**REMARKS**

Appl. No. 09/644,859  
Amdt. Dated Mar. 16, 2004  
Reply to Office Action of Dec. 18, 2003  
Annotated Sheet Showing Changes

FIG. 1A PRIOR ART

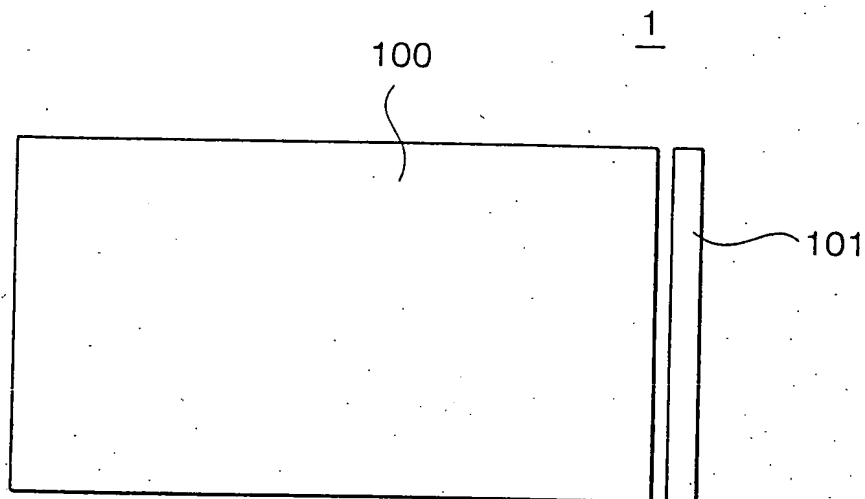
Figures 1A and 1B of the application have been objected as failed to include the legends of "Prior Art."

Applicant respectfully submits that the amended Figures 1A and 1B include legends reciting "Prior Art." Therefore, withdrawal of the objection to the drawings of the application is respectfully requested.
